## Big Darby Accord Advisory Panel

### **Heritage Estate** (Case AP-19-02)

Review regarding a Brown Township application requesting approval for a preliminary subdivision plan at 3855 Alton and Darby Creek Road.

## Development Review Checklist

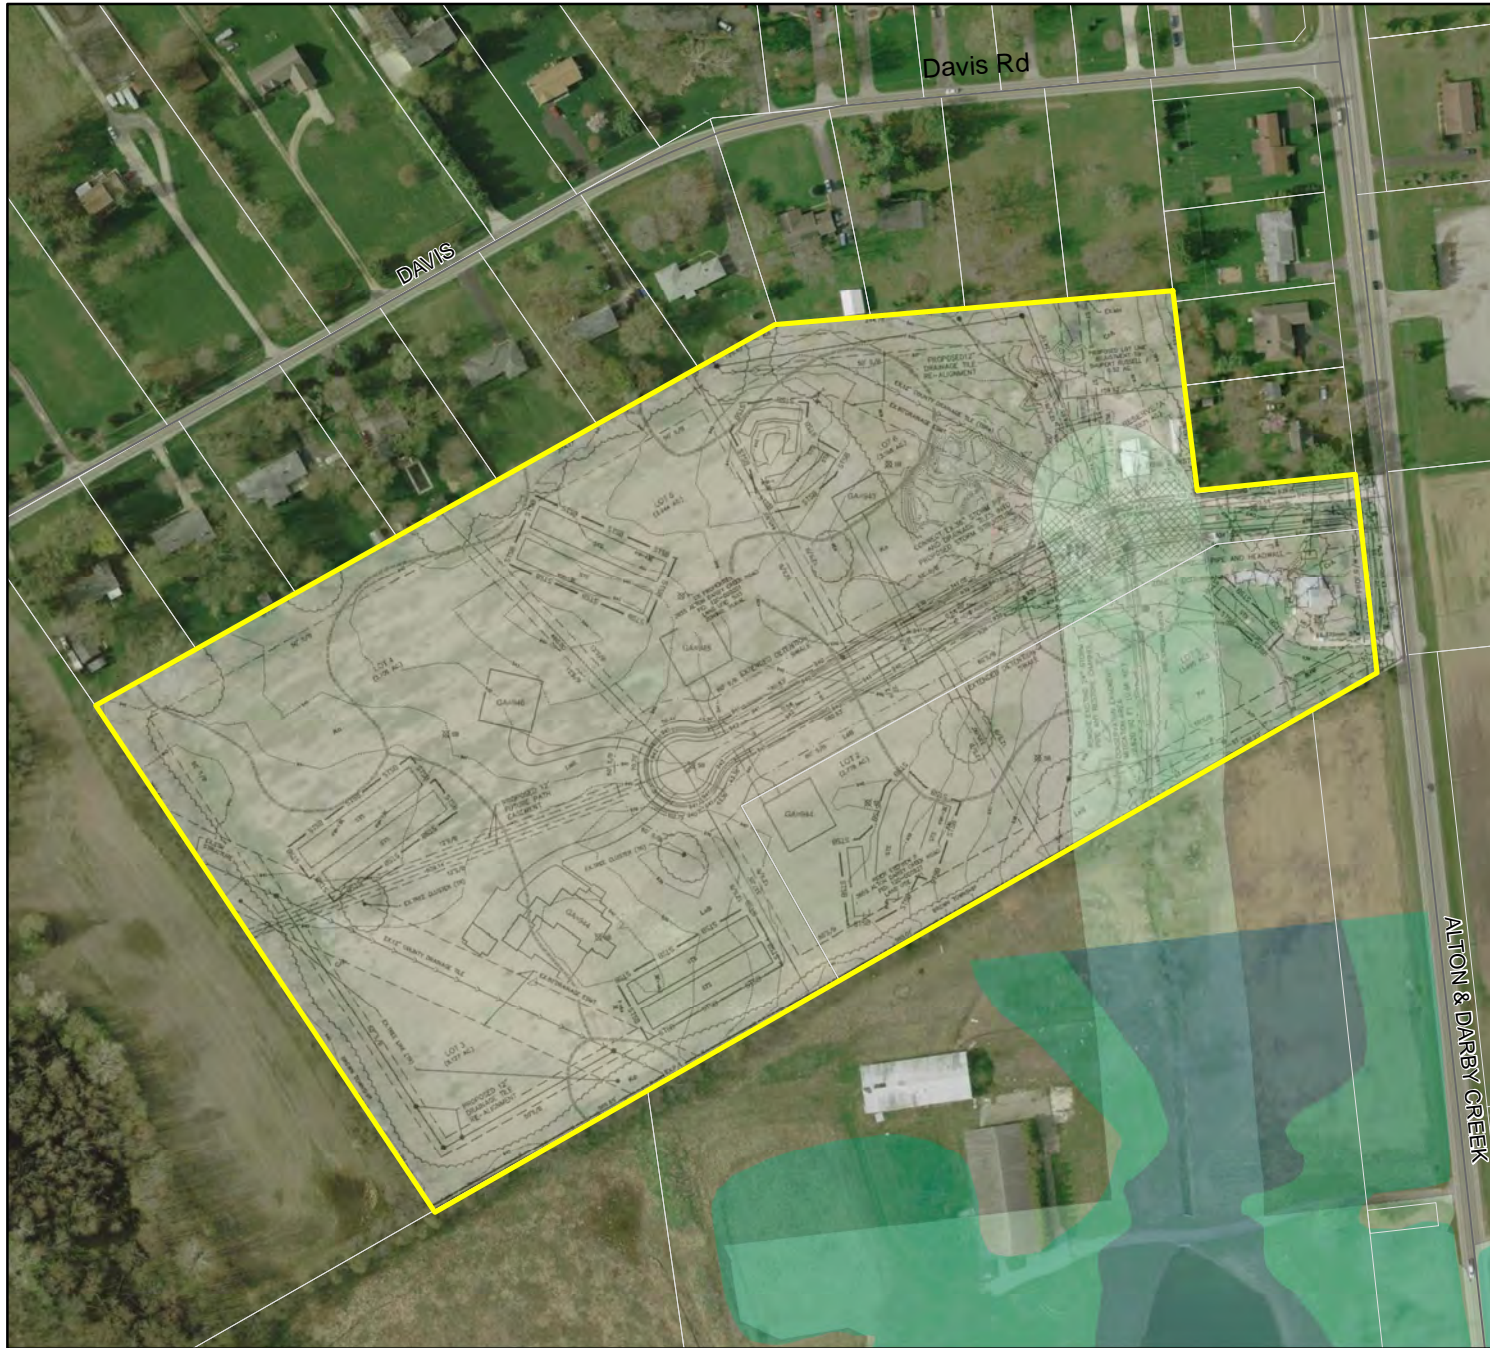
The Big Darby Accord Watershed Master Plan, adopted in 2006, includes two maps to guide development: a Proposed General Land Use Map and a Conservation Strategy Map. The Proposed General Land Use Map recommends the area for Conservation Development with 50 percent open space based on existing Rural zoning density. The Conservation Strategy Map shows the site as outside of tiered areas.

The proposal does not provide 50 percent dedicated openspace, however, the applicant is developing in accordance with their by-right Rural zoning.

The area to the west of the site in the City of Hilliard has already been rezoned for a much higher net density than what has been proposed for this site.

<b>Staff Recommendation</b>		
<p>Staff recommends:</p> <p style="margin-left: 40px;"><input checked="" type="checkbox"/> Approval</p> <p style="margin-left: 80px;"><input checked="" type="checkbox"/> with conditions (see below)</p> <p style="margin-left: 40px;"><input type="checkbox"/> Disapproval</p>		
<p>Reasons / Conditions:</p> <ol style="list-style-type: none"> <li>1. The applicant will be required to participate in the Big Darby Revenue Program.</li> <li>2. The applicant will be required to meet all Ohio EPA Standards as stated in the Big Darby Creek Watershed Construction Permit.</li> <li>3. The applicant will be required to place the stormwater infrastructure (detention swales) under the Ditch Petition Process for future maintenance.</li> <li>4. A maintenance easement must be dedicated to the Franklin County Engineer's Office over Hamilton Ditch measuring 25 feet from the top of bank on each side.</li> <li>5. The existing/proposed drainage tile must be held within an easement. There needs to be a "no tree zone" identified on the Development Plan and Plat that measures 80 feet wide over the drainage tile and pipes.</li> </ol>
